**RESOLUTION No. 12/13-35
CITY OF DAYTON, OREGON**

Title: A Resolution Adopting Public Works Design Standards Update No. 5

SUBJECT: Public Works Design Standards Update No. 5

LAST REVISION DATE: MAR 2010	COPYRIGHT 1995 WESTEC ENGINEERING, INC.
TAPPING REQUIREMENTS, 1-1/2" AND LARGER SERVICE	
(NTS)	
DAYTON, OR	DETAIL NO. 517

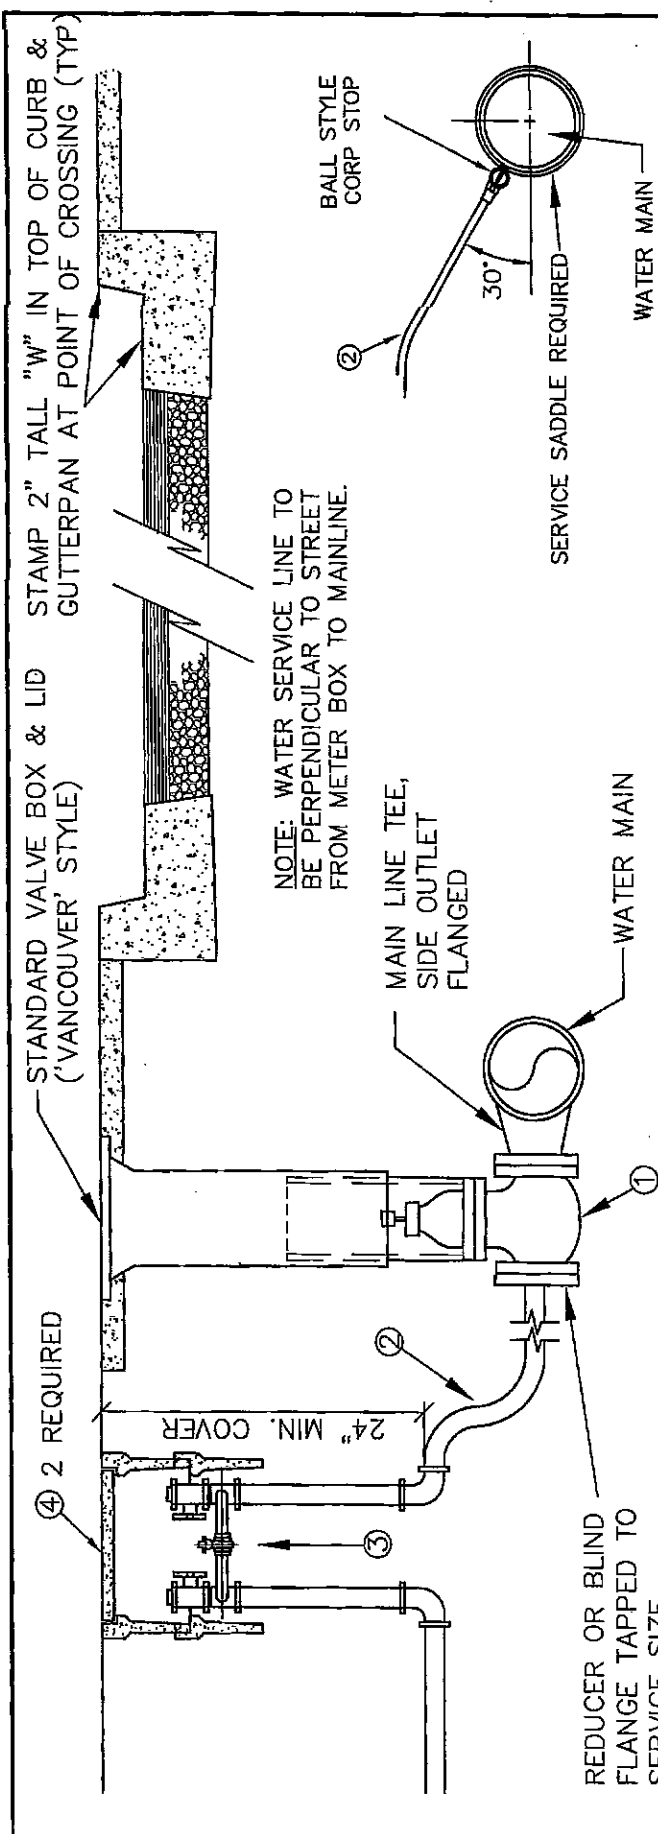
66. Detail 515: The callout number for the box lid was corrected. The revised detail (see attached) is dated 2/11.
67. Detail 517: The meter box drawing was modified to match the configuration shown on Detail 516. The revised detail (see attached) is dated 2/11.

LAST REVISION DATE: OCT 2012	JO #
1" COMBINATION AIR RELEASE VALVE (CARV) (NTS)	
DAYTON, OR	DETAIL NO. 518

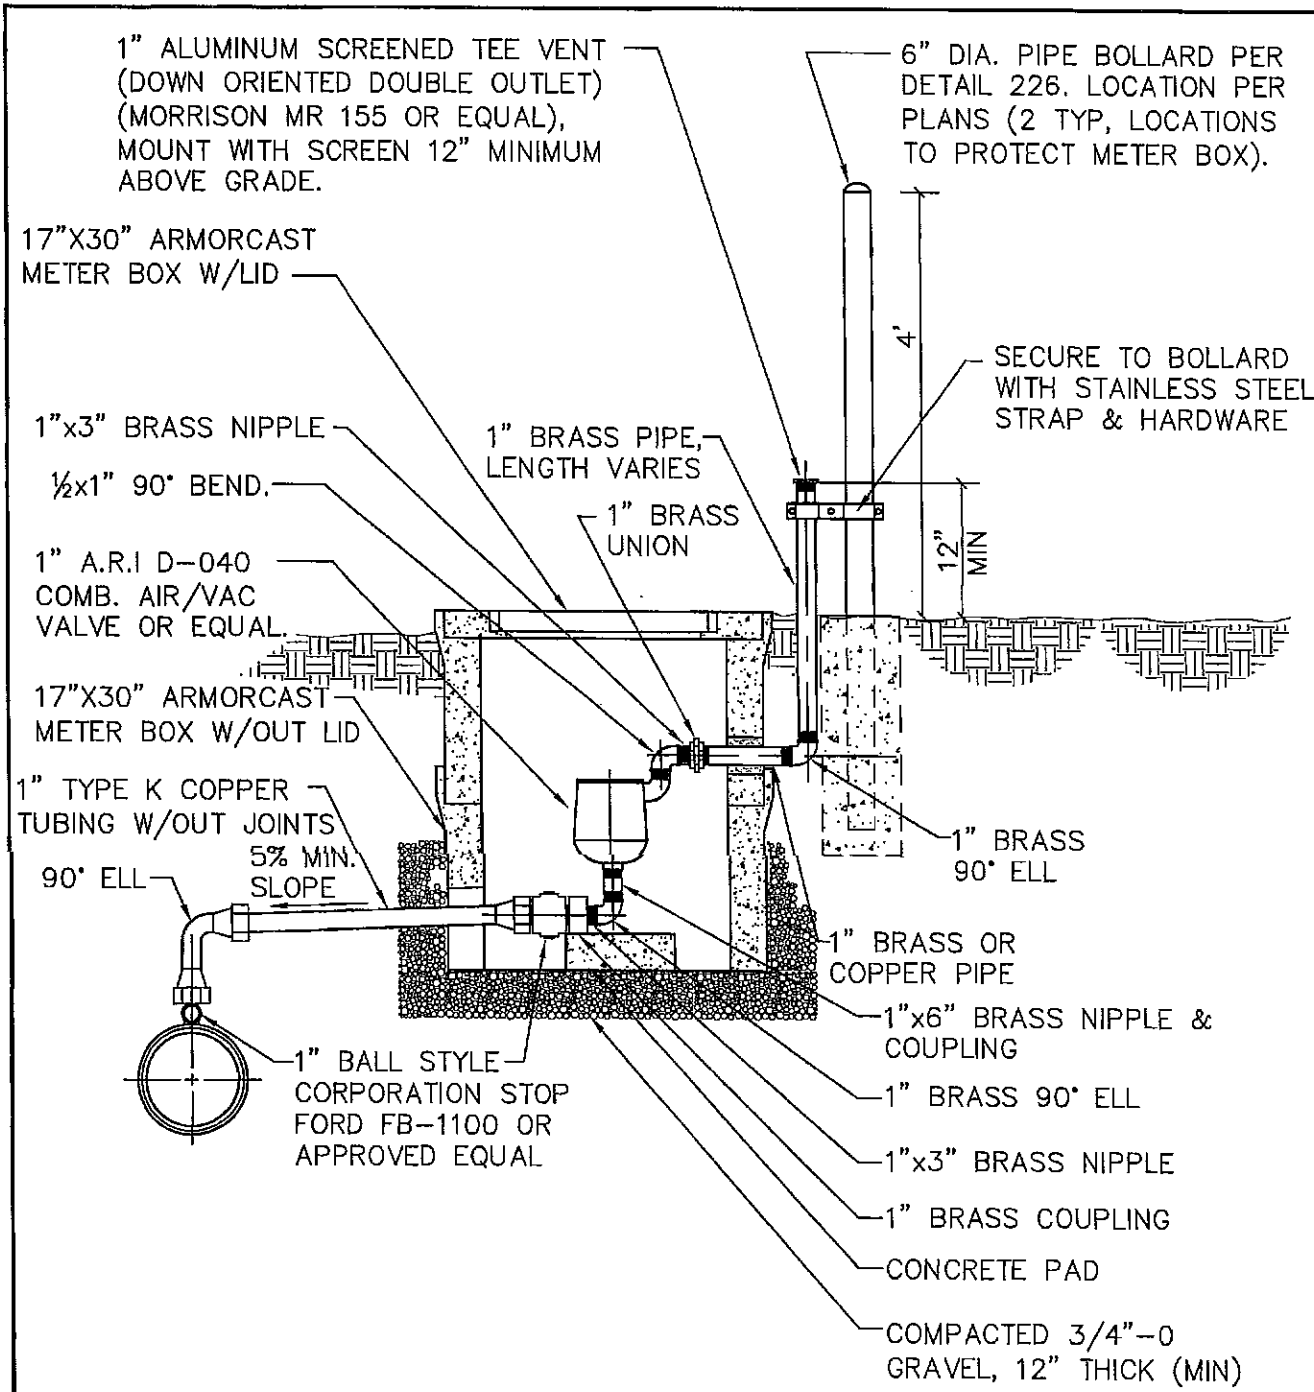
68. Detail 518: A new detail was prepared showing the configuration of a standard air release valve assembly. The new detail (see attached) is dated 10/12.

LAST REVISION DATE: FEB_2011	SP # STANDARD
3" DOMESTIC WATER METER	
(NTS)	
DAYTON, OR	DETAIL NO. 523

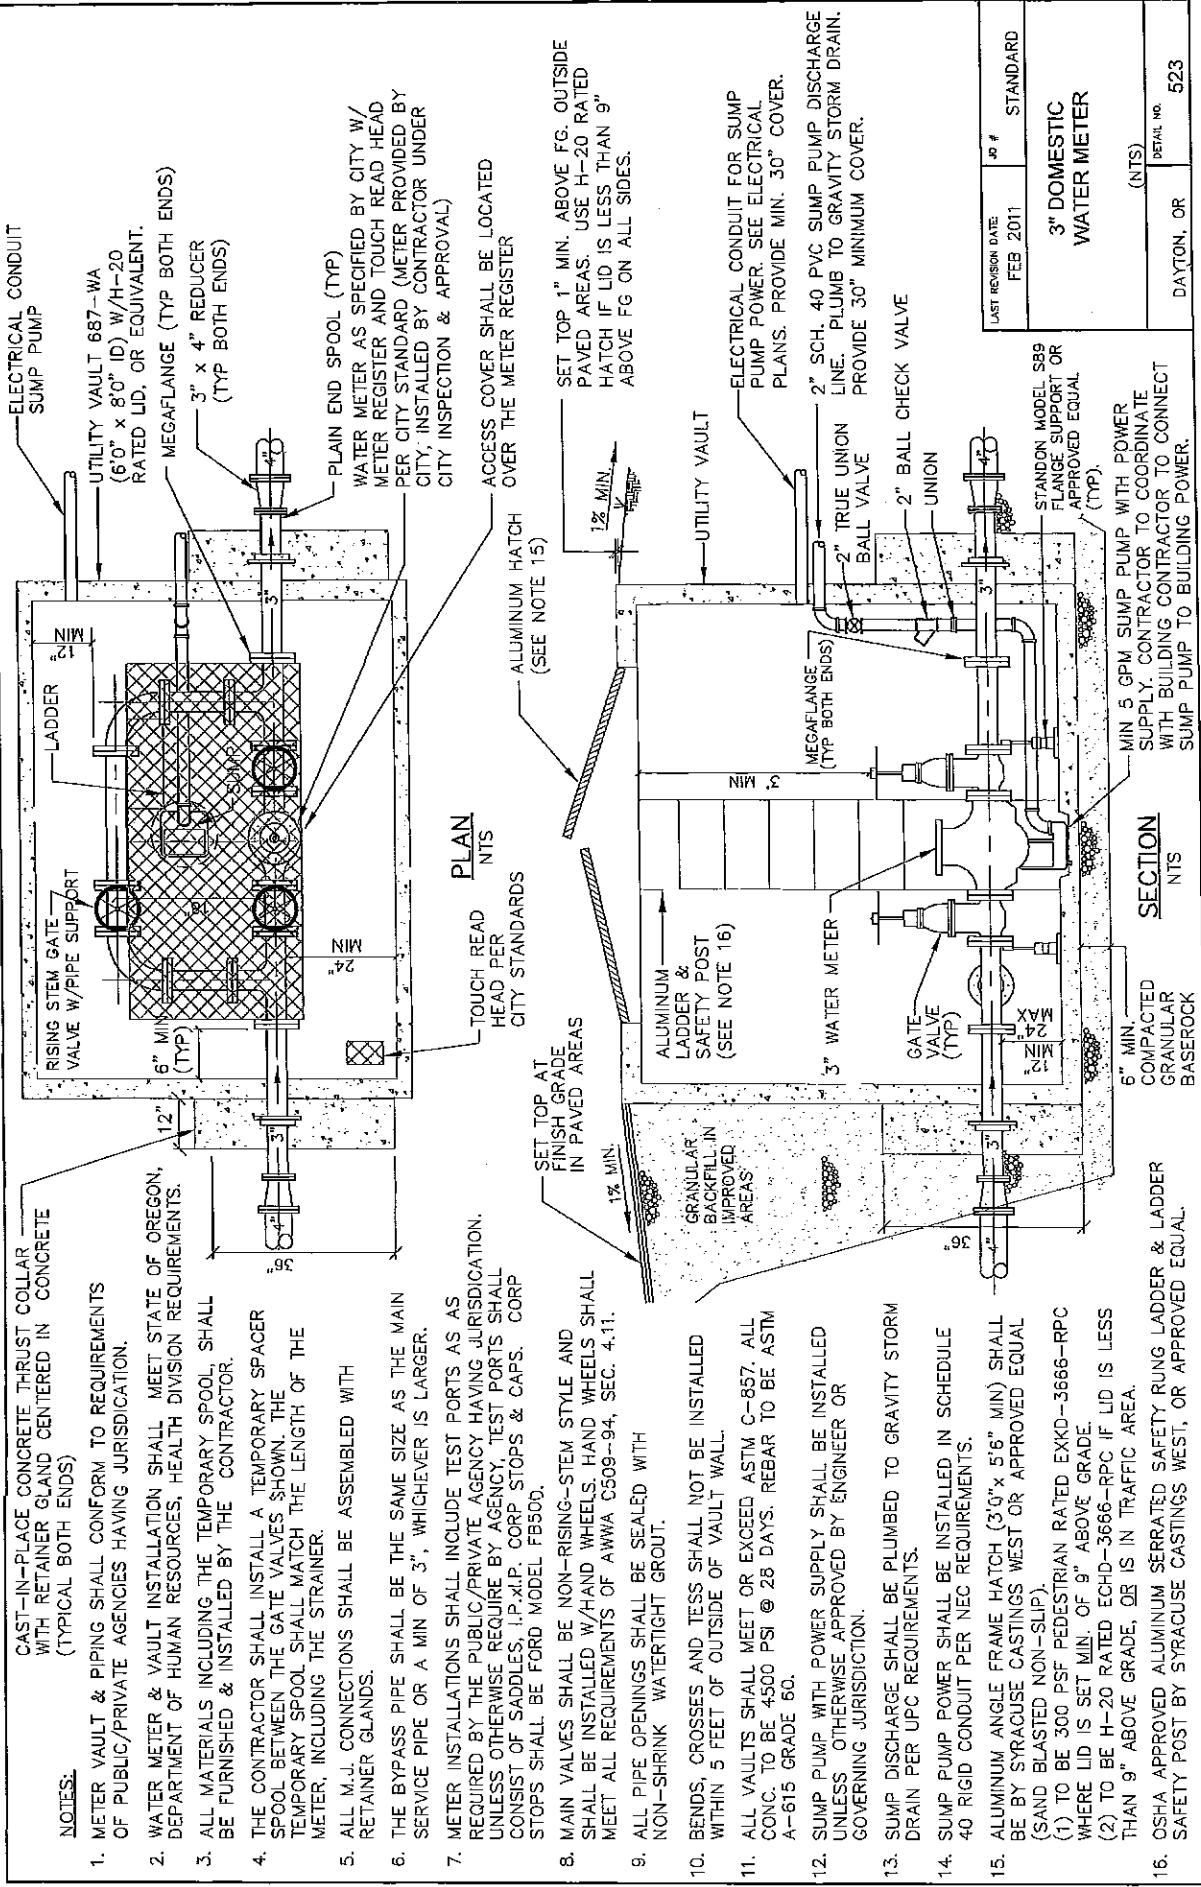
69. Detail 523 & 524: Updated & new details were added to address 3" & 4" water meter assemblies. The new details (see attached) are dated 2/11.

LAST REVISION DATE:	40 #	STANDARD
DEC 2012		
4" DOUBLE CHECK DETECTOR ASSEMBLY W/FDC (NTS)		
LAFAYETTE, OR		DRAWING NO. 554

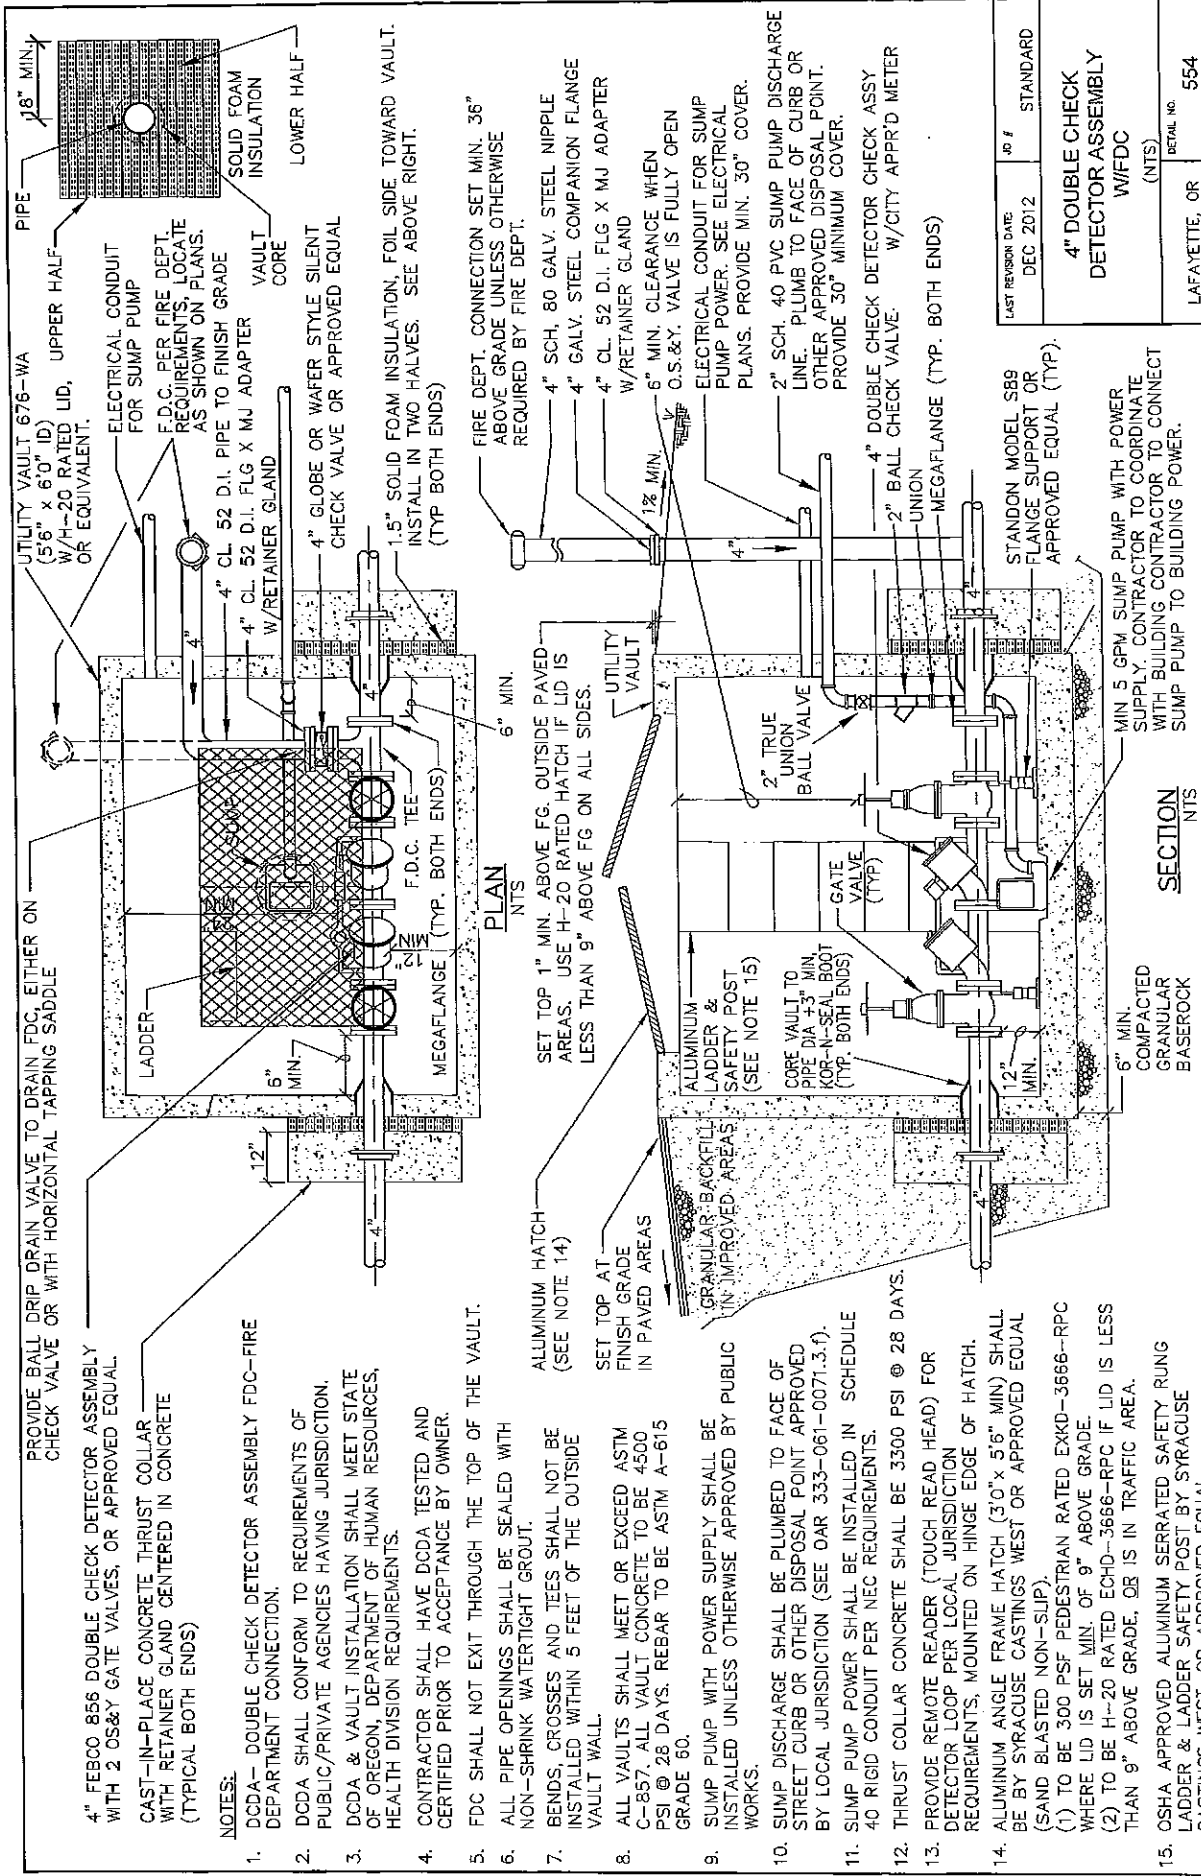
70. Detail 554, 555 & 556: Updated details were added to reflect current standards for FDC backflow vaults & hatches, and the installation of a City approved meter on the detector loop. The new details (see attached) are dated 12/12.
71. Detail 560 & 561: New details were added to show a typical configuration of a check valve or drain valve on an FDC line when the backflow device is located inside the building, and the FDC riser is required by the Fire Chief to be located away from the building. The new details (see attached) are dated 2/13.
